Subject: **Request for Modification for Section 404 Individual Permit and Section 401 Water Quality Certification** for the I-40/I-77 interchange improvements including I-40 from west of SR 2003 (Radio Road) to SR 2158 (Old Mocksville Road) and I-77 from south of SR 2321 (East Broad Street) to south SR 2171 (Jane Sowers Road) in Iredell County. Division 12, TIP I-3819B. Debit \$570.00 from WBS 34192.3.2

Revisions resulting in changes to permitted impacts are proposed at two impact sites (Sites 22 and 23). Two new impact sites (Sites 22A and 22B) have been added within the footprint of the previously permitted Site 22. The changes to these sites are described below.

PERMIT DRAWING
SHEET 1 OF 67
Rev. 11/29/2022

PERMIT DRAWING
SHEET 30 OF 67
 Rev. 11/29/2022

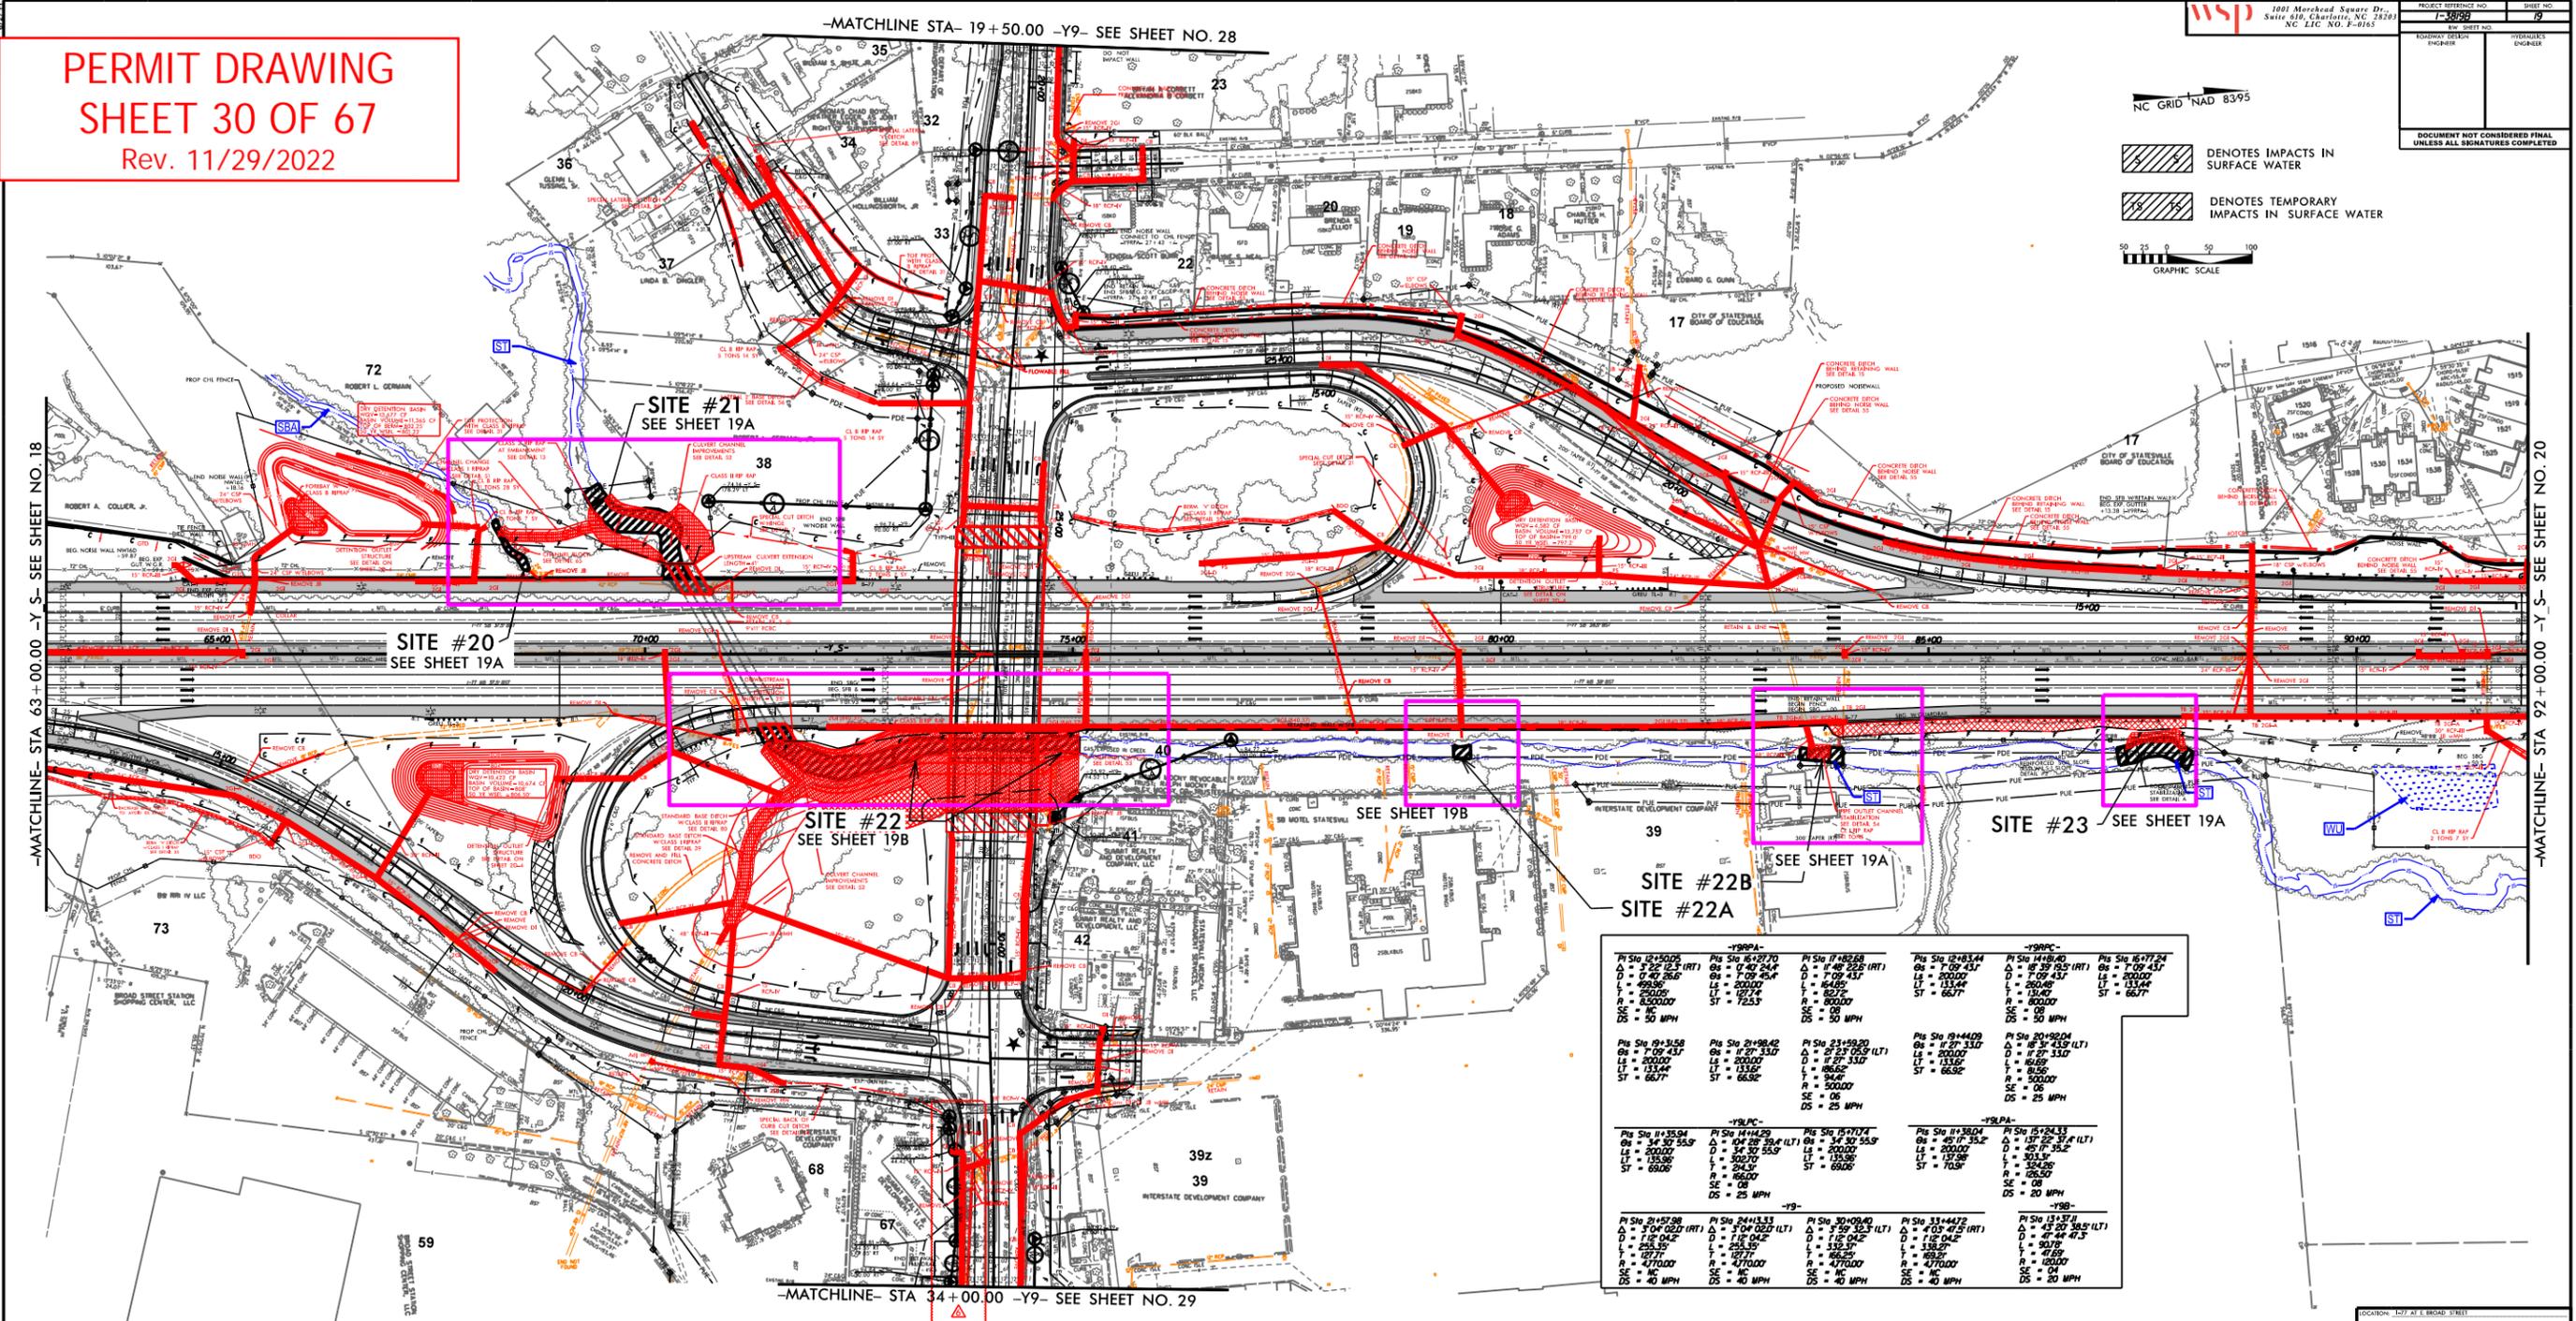
NOTE: AT THE DIRECTION OF NCDOT, JS LINES HAVE BEEN MODIFIED ALONG SITES 21, 22, AND 23 TO FOLLOW THE SURVEYED TOPOGRAPHY. NO RIPRAP WILL BE PLACED IN THE STREAM BED ALONG AREAS OF BANK STABILIZATION.

PERMIT DRAWING
SHEET 31 OF 67
 Rev. 11/29/2022

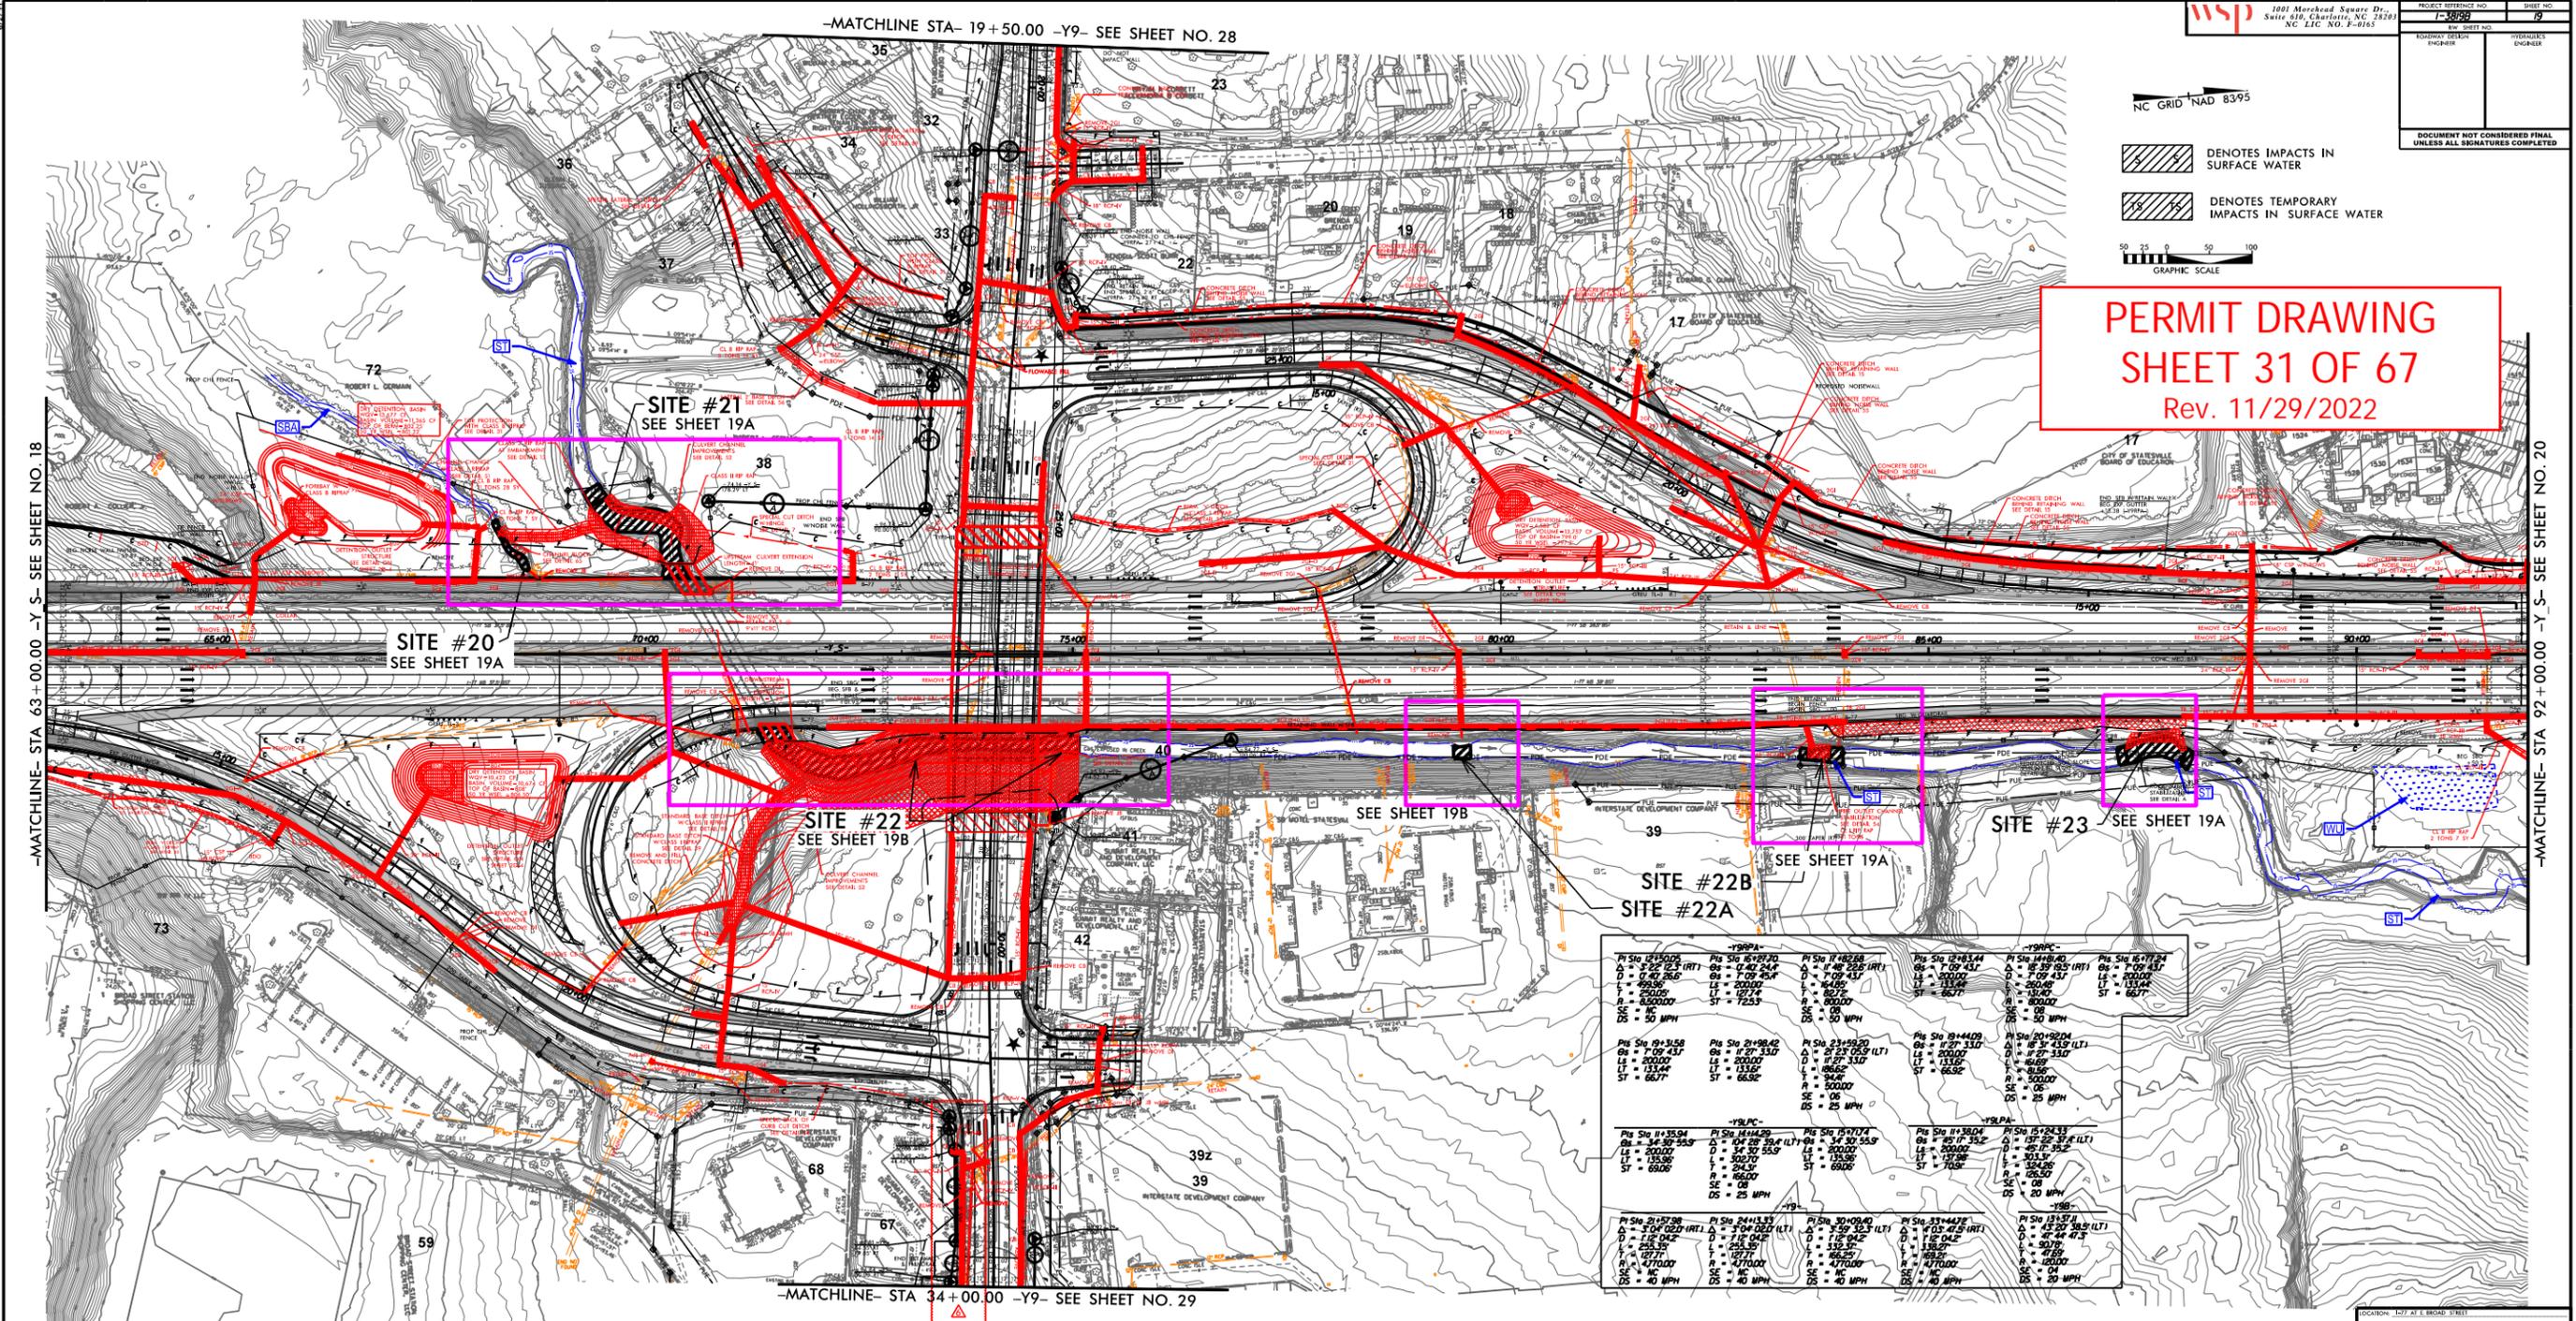
NOTE: AT THE DIRECTION OF NCDOT, JS LINES HAVE BEEN MODIFIED ALONG SITES 21, 22, AND 23 TO FOLLOW THE SURVEYED TOPOGRAPHY. NO RIPRAP WILL BE PLACED IN THE STREAM BED ALONG AREAS OF BANK STABILIZATION.

SITE #22

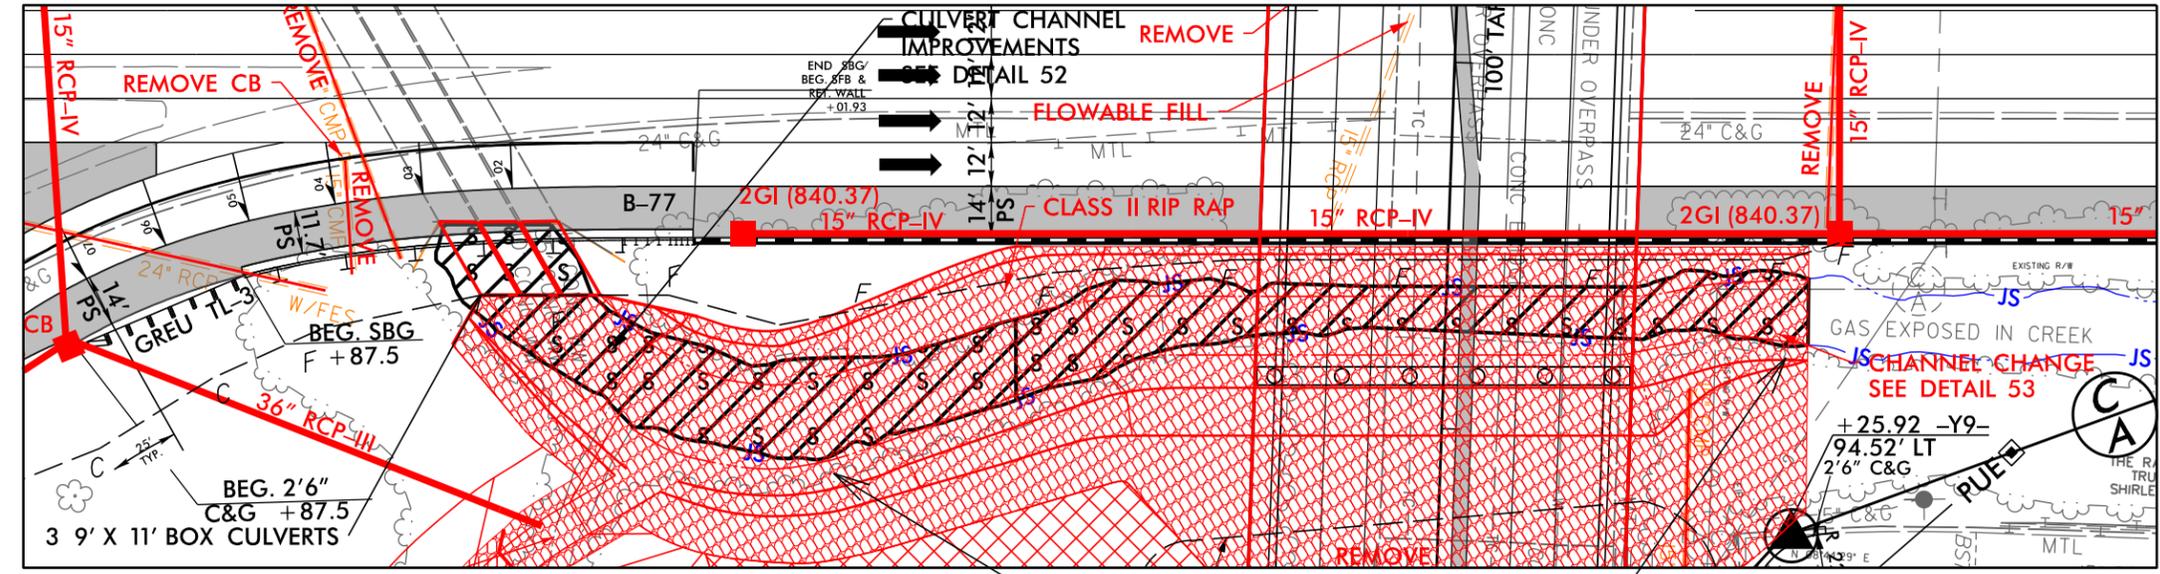
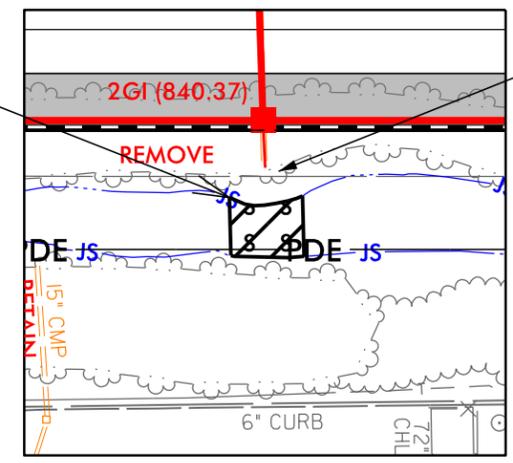
The previously permitted design at Site 22 included 901 linear feet of permanent stream impact from bank stabilization (Class II riprap) along stream ST, 185 linear feet of permanent stream bed stabilization impacts, 45 linear feet of 9' x 11' reinforced concrete box culvert (RCBC) extension, and 225 linear feet of permanent new channel stream (i.e., channel change) impacts. Per guidance from NCDWR, the 901 linear feet of proposed rip rap stream bank stabilization along ST has been eliminated from Site 22; instead the project now includes stabilization of the banks with black willow (*Salix nigra*) live stakes. Live stakes were installed in spot locations along the stream banks and no grading of the stream banks was conducted, therefore this activity is not a Section 404-regulated activity. Live staking was also installed beyond the jurisdictional limits of the stream between the top of bank and the retaining wall in this area. All other impacts at Site 22 remain unchanged. Sites 22A and 22B, discussed below, include minor riprap stream

Note that the 225 linear feet of new channel (i.e., channel change) impacts originally approved at Sta. 72+89 – 75+10-Y were inadvertently mislabeled as stream bank stabilization in the Wetland and Stream Impact Summary Table in the October 20, 2021 permit modification #2 submittal. Although incorrectly labeled, the overall amount of permanent stream impacts and stream bank stabilization impacts for the entire project were correctly calculated and reported. The attached Wetland and Stream Impact Summary Table has corrected the impact type for this location.

SITE #22A

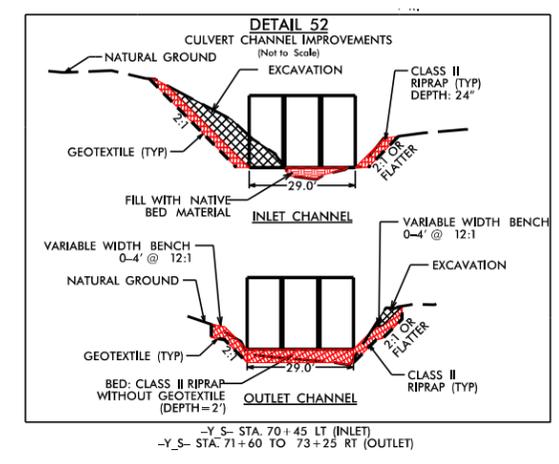
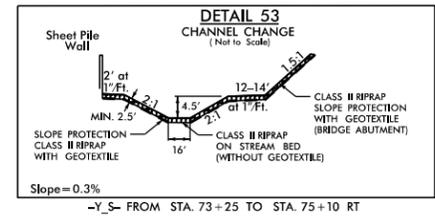
Site 22A is situated within the former stream bank stabilization portion of Site 22. At Site 22A, 20 linear feet of stream bank stabilization may be required at Stream ST to allow the contractor to stabilize the slope, if needed, following possible removal of an existing 15-inch reinforced concrete pipe (RCP).

BANK STABILIZATION MAY BE NEEDED AFTER EXISTING PIPE IS REMOVED. USE DETAIL B AS NEEDED*.
